**CITY OF WEST DES MOINES  
BOARD OF ADJUSTMENT COMMUNICATION**

**Meeting Date:** December 18, 2019

**Item:** Height Variance, 329 5th Street – Vary the maximum building height from thirty-six feet (36') to forty feet (40') for the elevator shaft of a proposed mixed use building – Junction House 329, LLC (VAR-004570-2019)

**Requested Action:** Request approval of a Building Height Variance

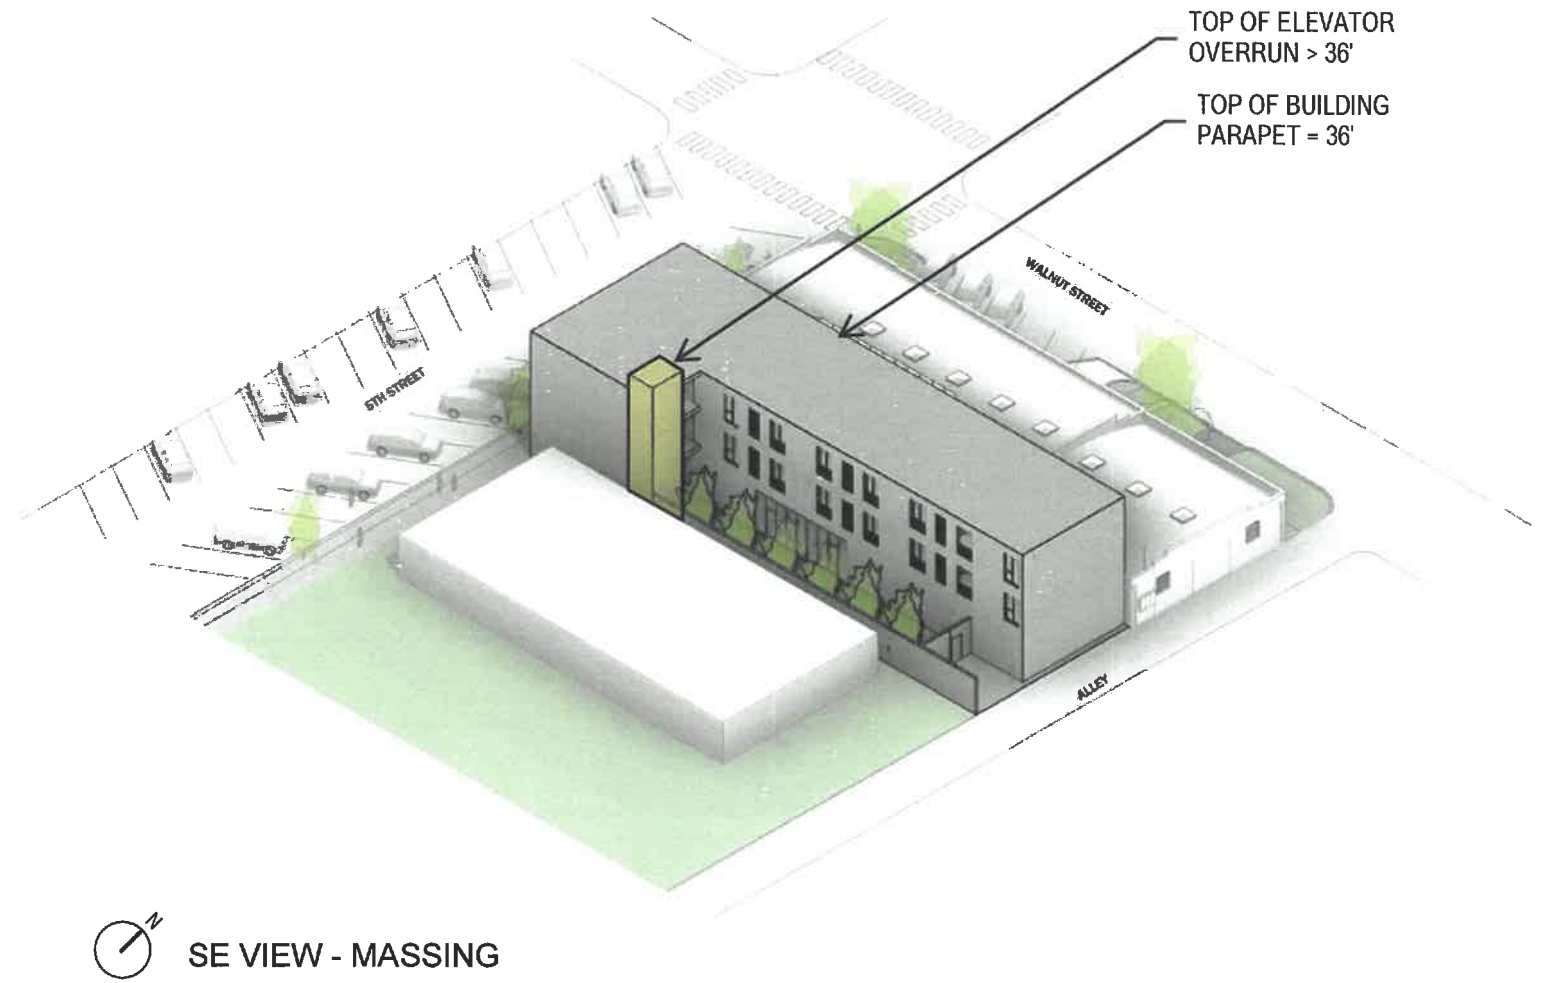
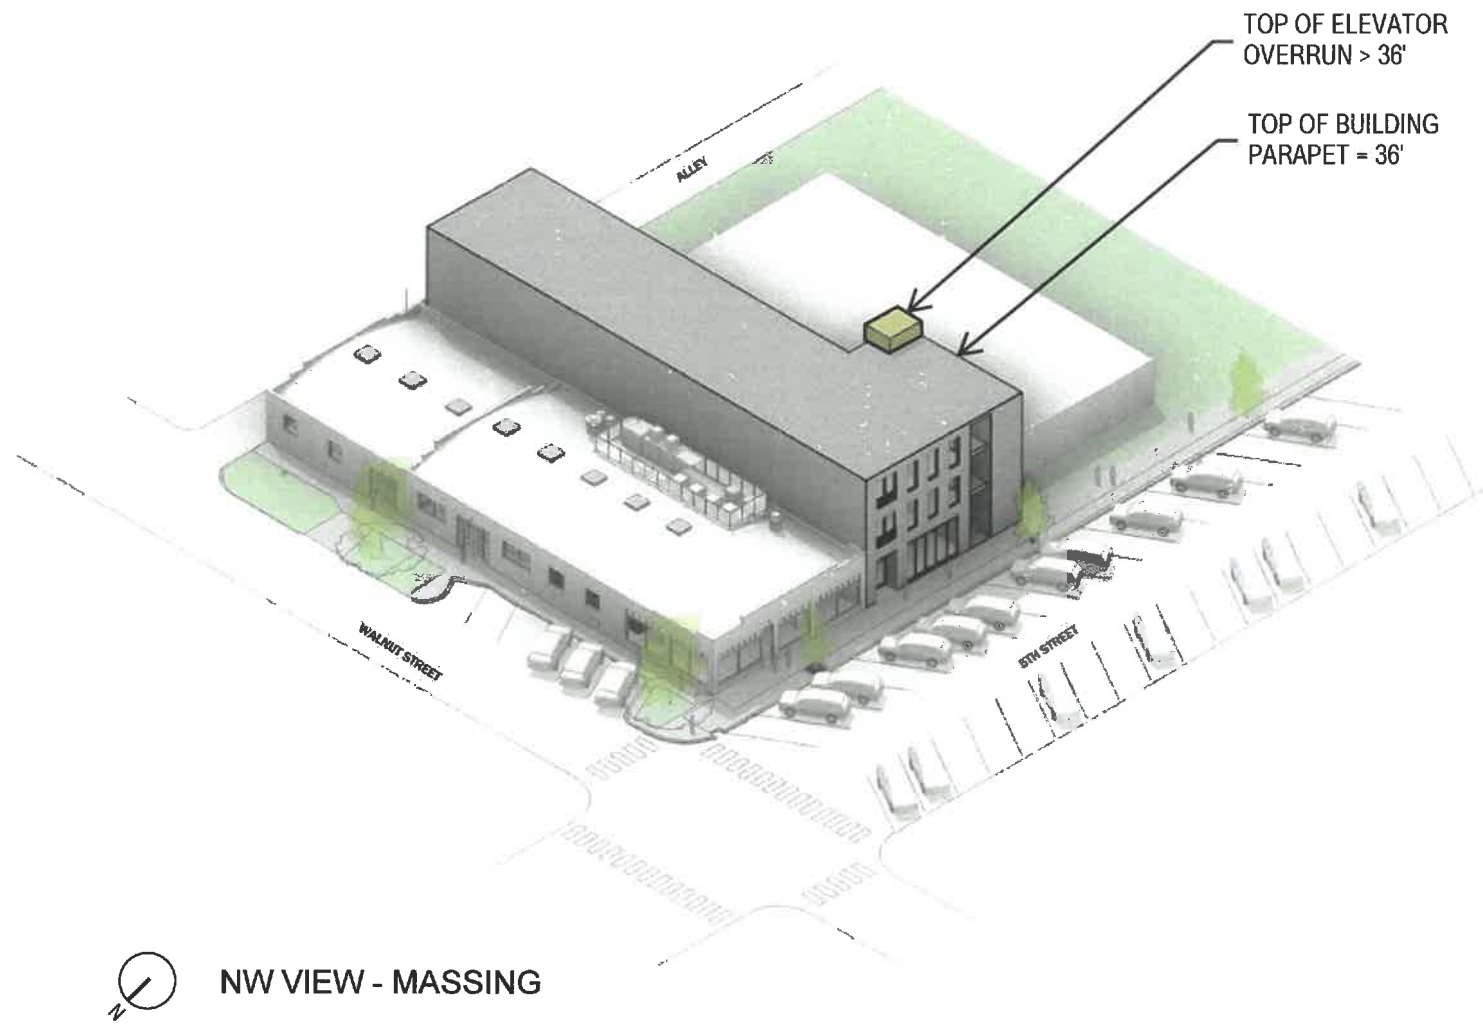
Roof mounted mechanical equipment is not included in the height calculation as the dimension is taken from the parapet (edge of the building, which could be higher or lower than any roof mounted equipment) and mechanical equipment is not considered a permanent element of the building. An elevator overrun is the mechanical equipment above the highest stop of the elevator car and is a functional requirement for the operation of the elevator. The elevator shaft that encloses the overrun is the subject of the request as it is located along the edge of the building rather than setback onto the middle of the roof where it could be treated as equipment. Because of its location at the edge of the building, the shaft enclosure becomes an element of the building facade and in this case, is a higher parapet than the remainder of a building due to the additional height needed for the elevator overrun.

- Per Table 7.8 in the City of West Des Moines code, buildings zoned in the Valley Junction Business (VJHB) district shall have a height limitation of 36'. It is our understanding that allowable height of 36' in the VJHB district was set at that height to allow construction of up to three-story buildings. The proposed mixed-use project is the first three-story new construction building in the VJHB, which is a special circumstance related to size of the building which do not apply generally to comparable properties in the same zone. The entire proposed three-story mixed-use building development at 329 5<sup>th</sup> Street complies with the 36' height requirement with exception of the elevator shaft. Per the 2015 International Building Code, an elevator is required for the proposed mixed-use project and all elevator manufacturers require additional height at the top of the elevator shaft for elevator overrun, which is a functional, maintenance and safety requirement. The footprint of the elevator shaft (75 +/- sf) represents 1.5% of the entire building footprint (5,200 +/- sf). Which means that 98.5% of the building footprint complies with the 36' height requirement with the only reason the elevator shaft is taller than 36' is due to functional, maintenance and safety requirements enforced by all commercial elevator manufactures. Refer to attached site plan and 3-dimensional aerial views for location and extents of elevator shaft.

shaft is taller than 36' is due to functional, maintenance and safety requirements enforced by all commercial elevator manufactures. Additionally, the elevator shaft has been setback approximately 30' from the west property line, which is the primary public façade on 5<sup>th</sup> Street, to mitigate the visibility of the small portion of the building that would be taller than 36' (elevator shaft only). Refer to attached site plan and 3-dimensional aerial views for location and extents of elevator shaft.

2. That there are special circumstances or exceptional characteristics applicable to the subject property with regard to size, shape, topography or locations, which do not generally apply to comparable properties in the same vicinity and zones.  
*The project site is a typical narrow and reasonably flat commercial lot in Valley Junction. It does not appear that there are any physical constraints of the site that would differentiate the code compliant potential of this property from any other in Valley Junction. The current bulk regulations for the district stated in city code reflect existing context of buildings in Valley Junction, and the existing building heights are products of the construction techniques and technology of the turn of the century. Elevators were rare and buildings were limited in height because access to upper floors was only by stair. Building and accessibility codes today require accessible units on at least the lowest level of living. City code does not allow living units on the first floor of buildings in the Valley Junction Historic Business (VJHB) District. To provide accessibility for the dwellings that must be located on the upper stories, an elevator is required. The mechanical equipment necessary for the elevator to operate requires a projection above the roof.*

*The granting of the variance would not adversely affect the health or safety of persons, would not be materially detrimental to the public welfare and would not be injurious to nearby properties or improvements. The Applicant has proactively worked to locate the elevator shaft away from the adjacent properties to mitigate the impact of the additional height.*
